Access Compliance Report

Public Rights-of-Way

(Curb Ramps)

Intersection ID: 24072	Main Street: DELOACH_CT	Cross Street: HAWK_CREST_CT	Location: E
ADA ID: 20C947941345	Ramp Type: PerpDiag	Initial Pass/Fail: Fail	Overall Compliance: No
Severity Score: 12.5			
Codes/Mitigation Info/Possible Solution		Field Measurements/Component Compliance

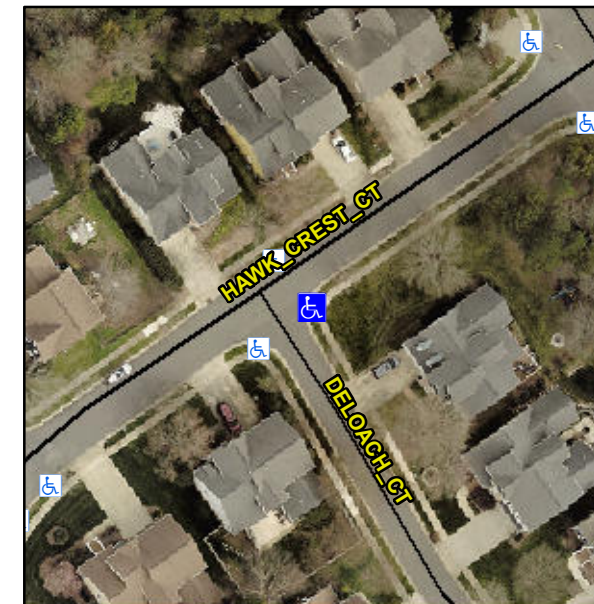
Not Found, R304.5.3

Compliance	Description	Data	Compliance	Description	Data
N/A	Ramp Length (in)	44.0	Yes	Ramp Slope (%)	8.2
Yes	Ramp Width (in)	61.0	No	Ramp XSlope (%)	5.7
N/A	Flare Type LT	N/A	N/A	Flare Type RT	N/A
N/A	Flare Slope LT (%)	N/A	N/A	Flare Slope RT (%)	N/A
N/A	Flare Traversable LT?	N/A	N/A	Flare Traversable RT?	N/A
N/A	Landing Length (in)	N/A	N/A	DWS Provided?	N/A
N/A	Landing Width (in)	N/A	N/A	DWS Contrast?	N/A
N/A	Landing Slope (%)	N/A	N/A	DWS Length (in)	N/A
N/A	Landing X Slope (%)	N/A	N/A	DWS Full Width?	N/A
N/A	Landing Curb? (Y/N)	N/A	N/A	DWS Offset (in)	N/A
N/A	Shared Landing?	N/A			
N/A	Gutter Ponding?	N/A	N/A	Gutter Slope (%)	N/A
N/A	Gutter Lip Ht (in)	N/A	N/A	Gutter X Slope (%)	N/A
N/A	Painted X Walk1?	No	N/A	Painted X Walk2?	No
	X Walk 1 Direction	To NW		X Walk 2 Direction	To SW
N/A	X Walk 1 Width (in)	N/A	N/A	X Walk 2 Width (in)	N/A
	X Walk 1 Slope (%)	5.3		X Walk 2 Slope (%)	2.8
	X Walk 1 X Slope (%)	5.4		X Walk 2 X Slope (%)	3.1

Remove & Replace Curb Ramp With Two New Directional Ramps or Equivalent.
